**Rezoning Application:** PD 25-0371  
**Zoning Hearing Master Date:** July 21, 2025  
**BOCC CPA Public Hearing Date:** September 9, 2025

Development Services Department

## 1.0 APPLICATION SUMMARY

## AGENCY REVIEW COMMENT SHEET

## 2.4 Proposed Site Plan (partial provided below for size and orientation purposes. See Section 8.0 for full site plan)

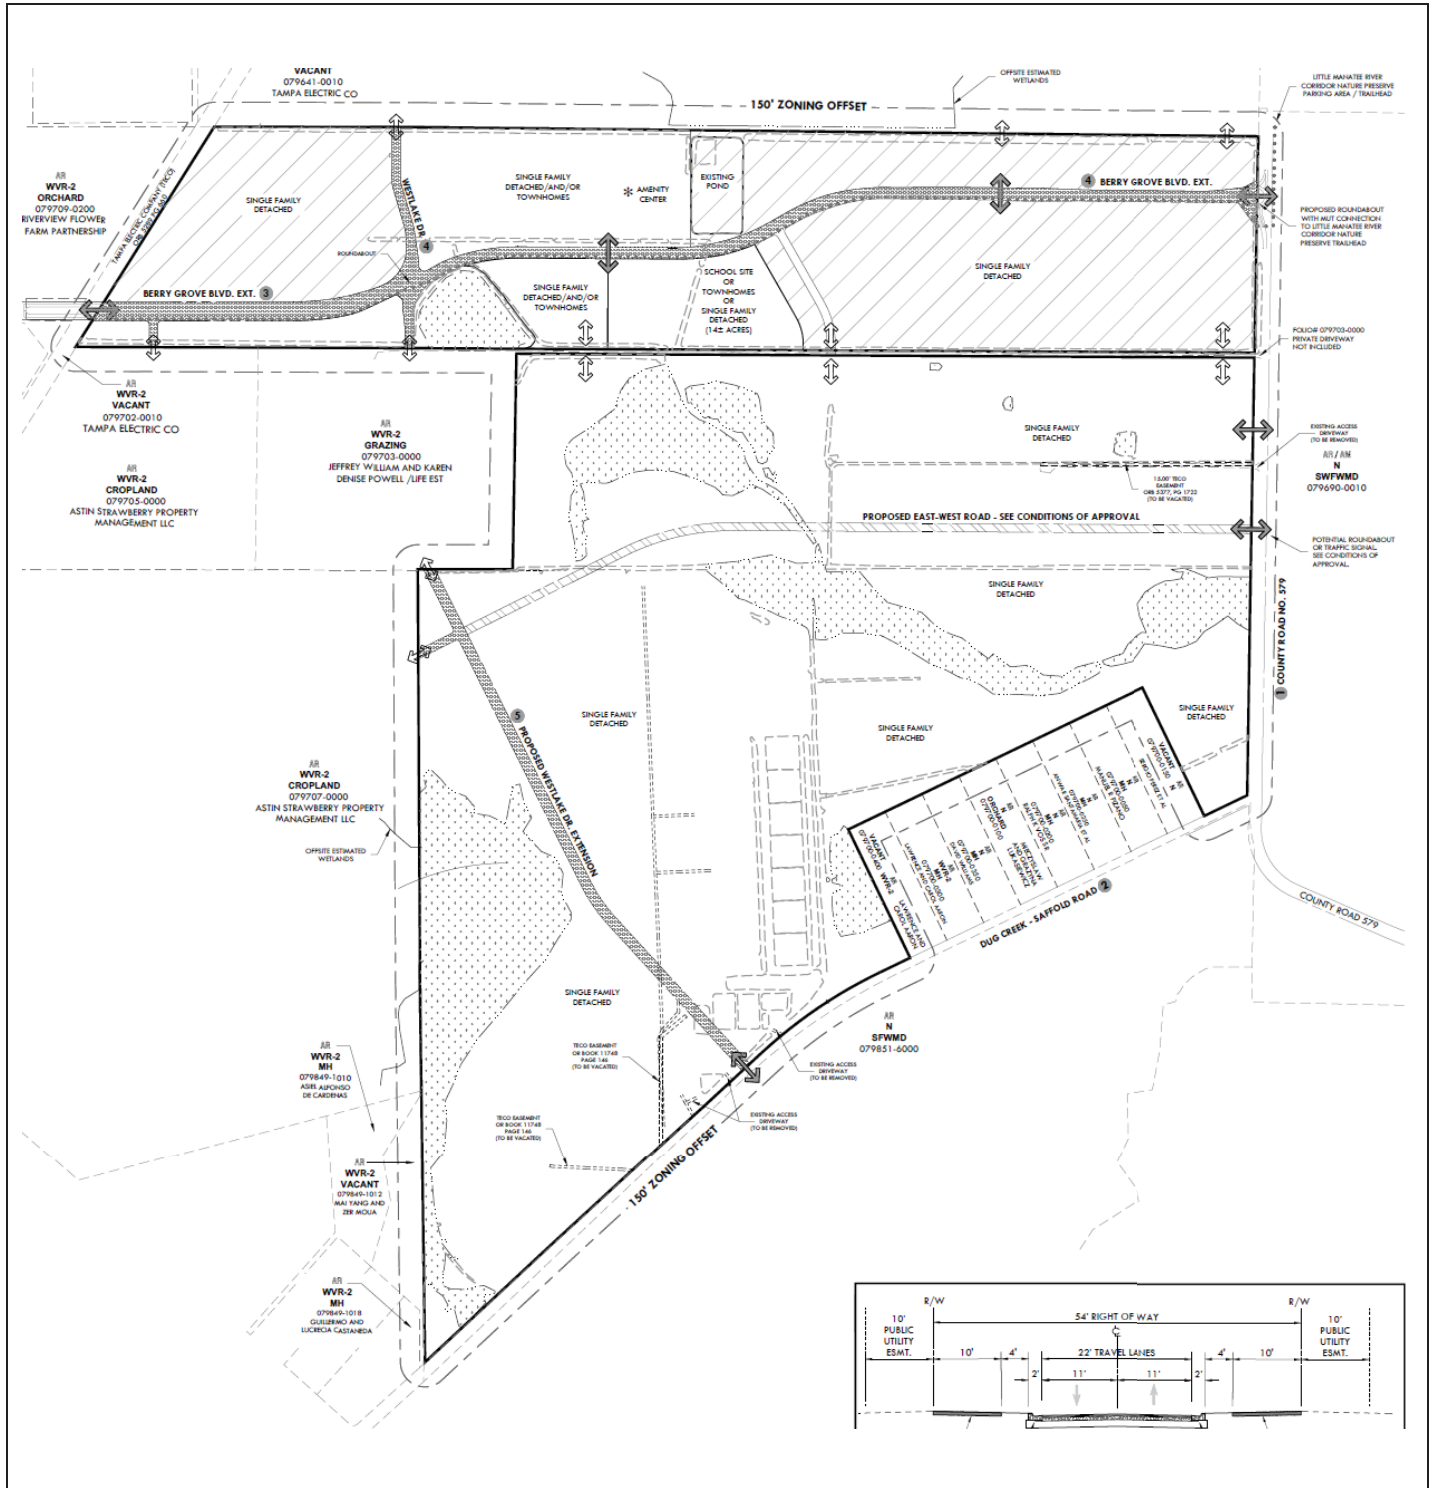
- 1. Within the Project Data Table, add footnote “(1)” to “Elementary School K-5” such that it is apparent the trip cap applies to all development within the project, not just total residential.
- 2. Within the Project Data table, correct the number of Elementary School students from “10000” to instead state “1000 students max.”
- 3. Within the Project Data table, revise “Proposed Uses” line from “Residential” to instead state “Residential and Potential School”.
- 4. Revise the Berry Grove Blvd. Typical Sections to remove any references to “Tier 1-1”.

- Prior to certification of the General Development Plan (GDP), the applicant shall revise the PD site plan to:
  - Within the Project Data Table, add footnote “(1)” to “Elementary School K-5” such that it is apparent the trip cap applies to all development within the project, not just total residential.
  - Within the Project Data table, correct the number of Elementary School students from “10000” to instead state “1000 students max.”
  - Within the Project Data table, revise “Proposed Uses” line from “Residential” to instead state “Residential and Potential School”.
  - Revise the Berry Grove Blvd. Typical Sections to remove any references to “Tier 1-1”.

## SEGMENTS GRAPHIC

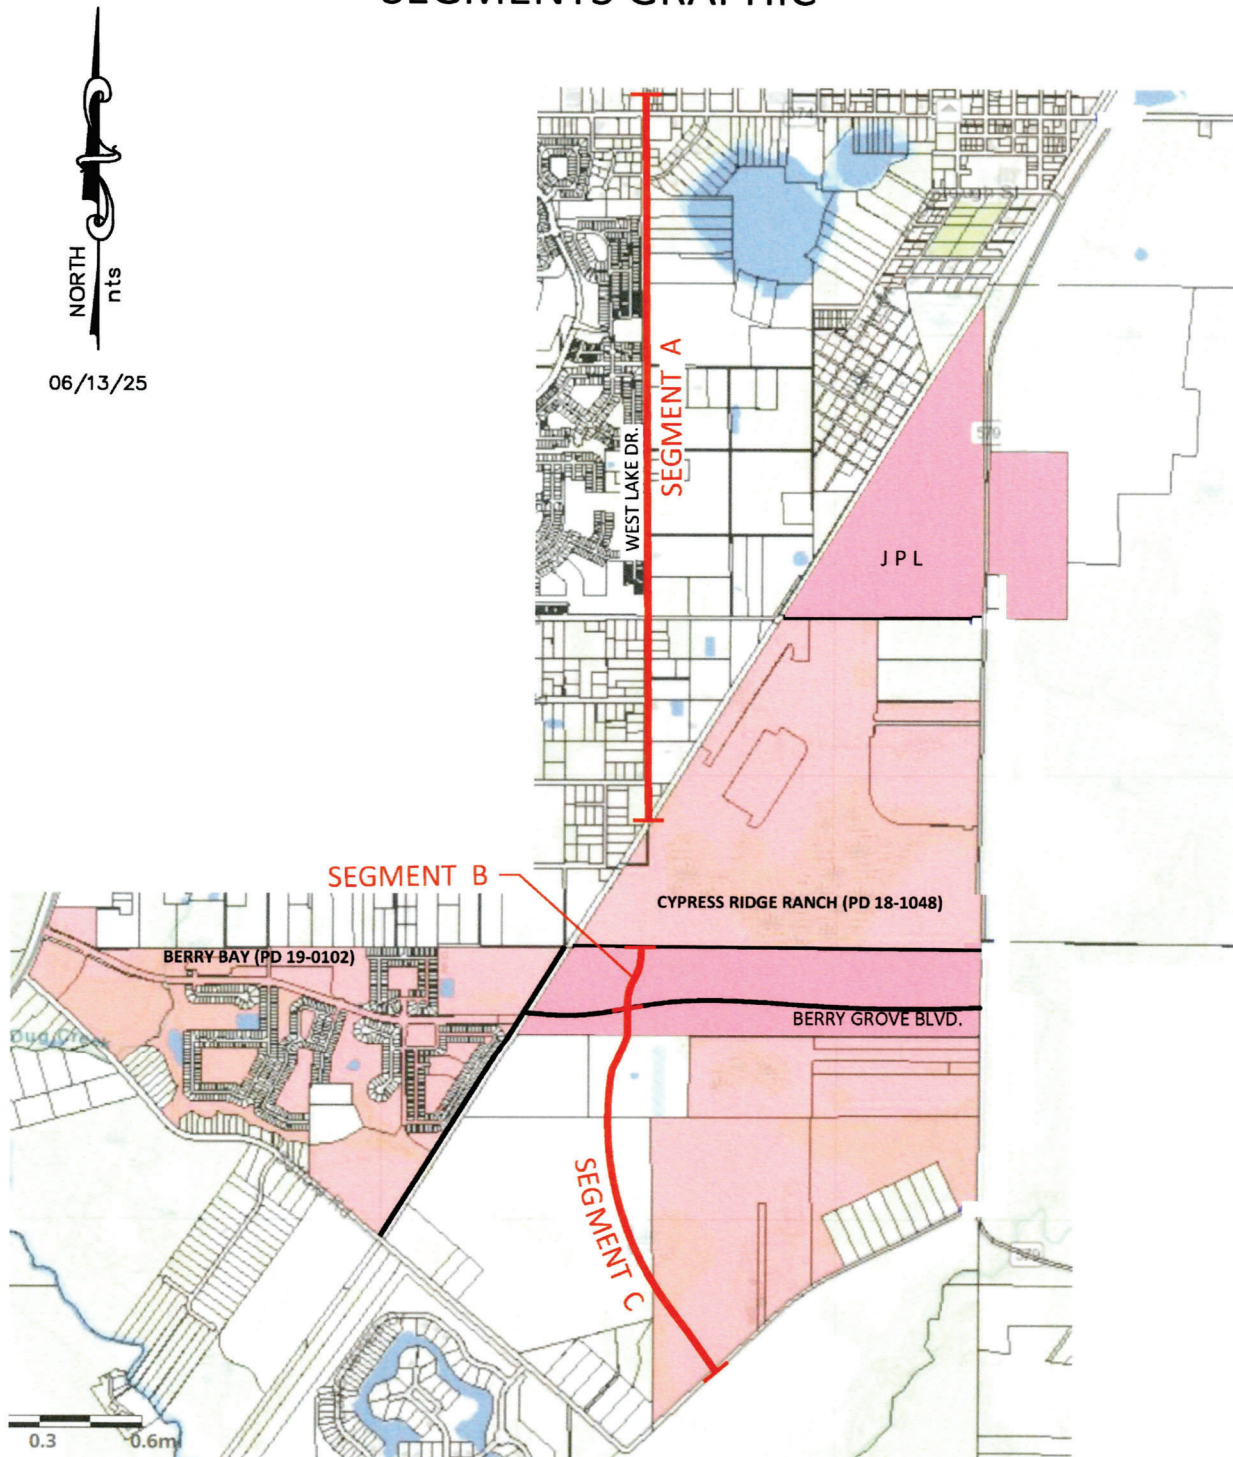
Staff notes that the graphic shown in the Design Exception request incorrectly depicts Segment A as inclusive of the area covered by Segment B. Staff has updated the graphic to reflect the correct summary and segmentation described hereinabove.

**SECTION A-1**

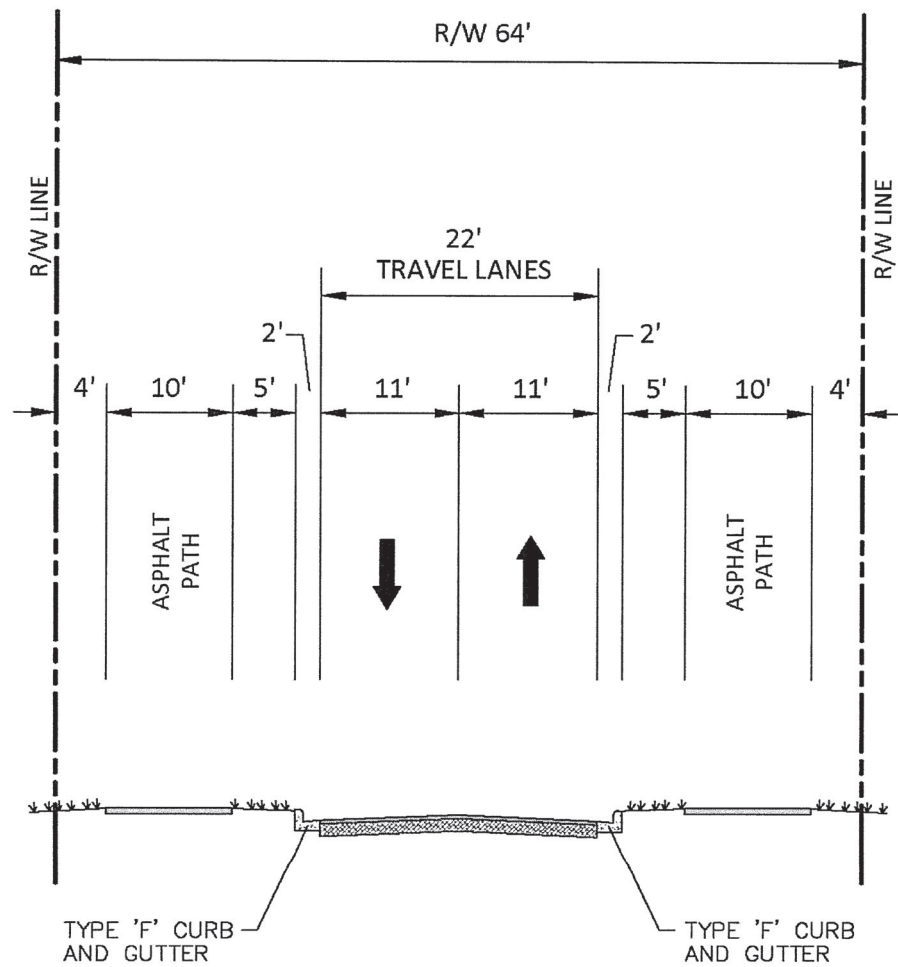
The developer proposes two (2) alternative sections. The first is where there is sufficient right of way to provide the proposed section which is shown in Typical Section A-1. Typical Section A-2 illustrates the proposed section where right of way is limited and/or there are design constraints. The primary difference in these sections is the distance from the back of the curb to the sidewalk. It should be noted that the distance between the back of the curb and sidewalk can vary depending on the right of way and roadway constraints. This section will be minimized to the greatest extent feasible. The sections include the following:

1. Bike Lanes – Due to the three (3) schools that are proposed along West Lake Drive, 10 foot sidewalks are proposed on each side of West Lake Drive in lieu of the bike lanes. From a safety standpoint, the 10 foot sidewalks provide a better option for students walking and riding bikes to school than students riding bikes within West Lake Drive or pedestrian and bikes on a 5 foot sidewalk. Due to right of way constraints along the roadway, it is not feasible to provide the bike lanes and the 10 foot sidewalks.
2. Sidewalk – 10 foot sidewalk on both sides of the roadway are proposed instead of the bike lanes. As stated above, given the roadway will serve the three (3) schools, the 10 foot sidewalks provide a better option for the school students.

**TYPICAL SECTION  
SEGMENT A  
C.R. 579**

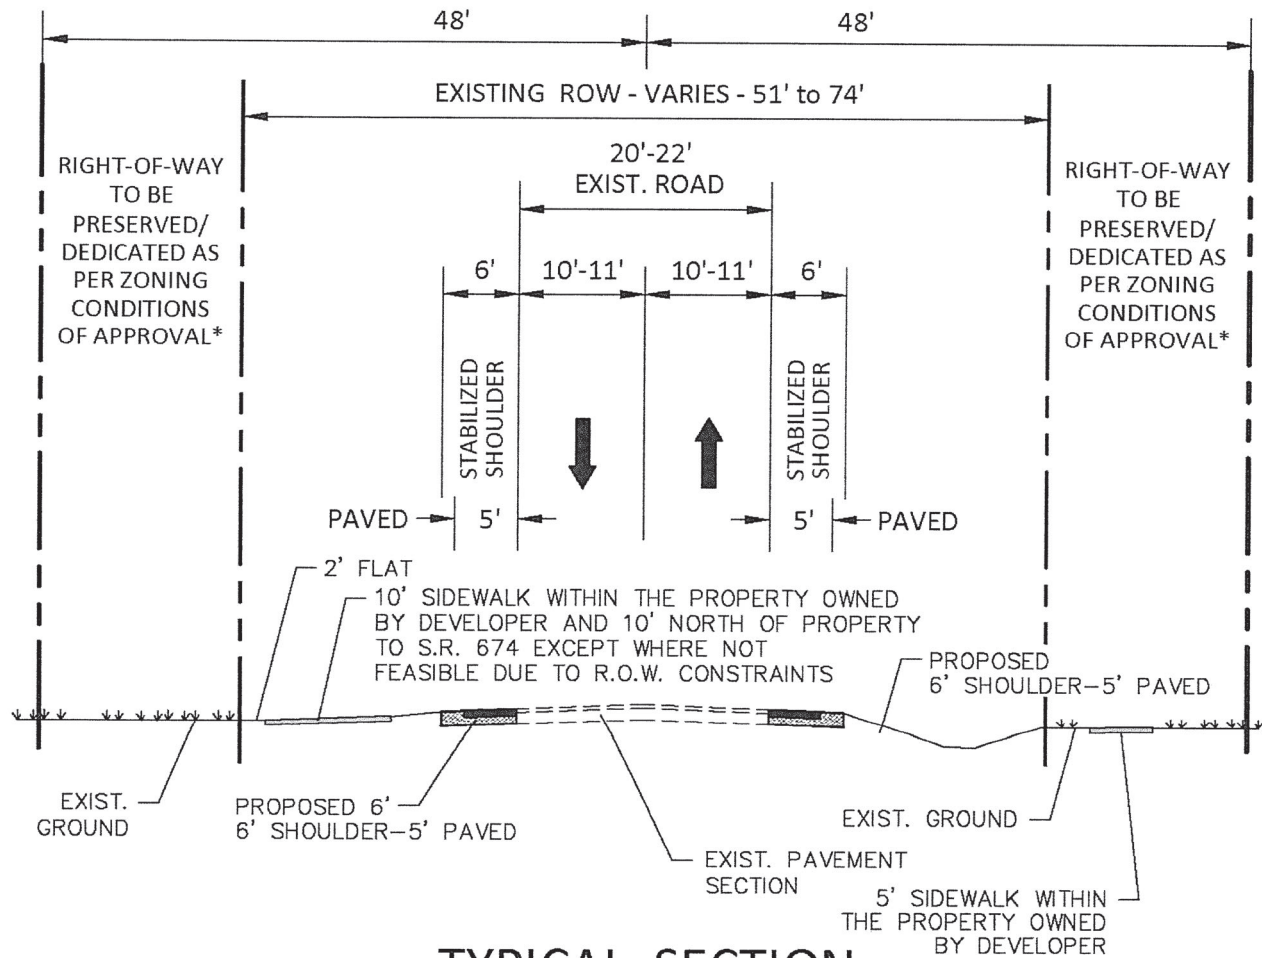
1. Right of Way – The right of way along this segment of CR 579 varies between approximately 74 feet to 90 feet. As shown in Figure 1, the developer does own property along the portion of the segment and has committed to providing 48 feet of right way on the west side to accommodate the proposed improvements.
2. Lane Width – TS-7 has 12 foot lanes. The existing lanes are 10 feet. This section proposes to maintain the existing lane width.
3. Shoulder – TS-7 has 8 foot shoulders with 5 feet paved. The proposed section has 6 foot stabilized shoulder with five feet paved.
4. Sidewalk – TS-7 has 5 foot sidewalk on both sides of the road. The proposed section provides a 10 foot sidewalk on the west side of CR 579.

**TYPICAL SECTION  
SEGMENT A  
SAFFOLD ROAD**

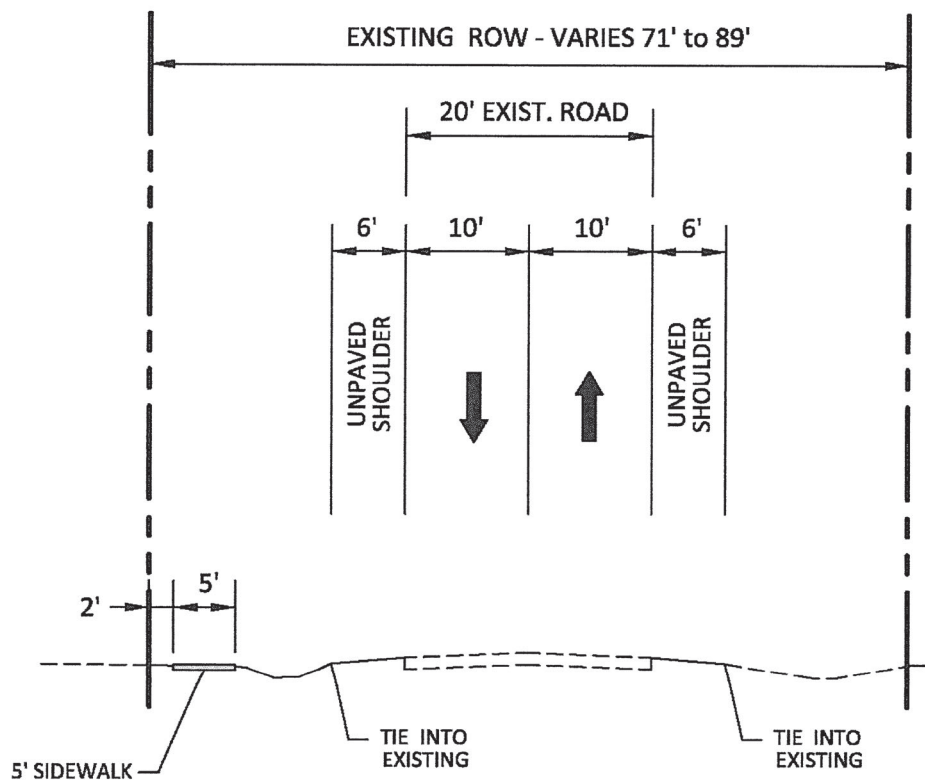
This section is along the portion of Saffold Road that the developer does not own any property. See Typical Section B for the section along the segment.

1. Right of Way – TS-7 has 96 feet of right of way. The right of way along the segment of Saffold Road varies between 71 feet to 89 feet.
2. Lane Width – TS-7 has 12 foot lanes. The proposed section is to maintain the existing lanes at 10 feet. Due to limited right of way, 12 foot lanes cannot be provided.
3. Shoulder – TS-7 has 8 foot shoulders with 5 feet paved. The proposed section has 6 foot stabilized shoulder.
4. Sidewalk – TS-7 has 5 foot sidewalk on both sides of the roadway. A 5 foot sidewalk is proposed along the north side of Saffold Road.
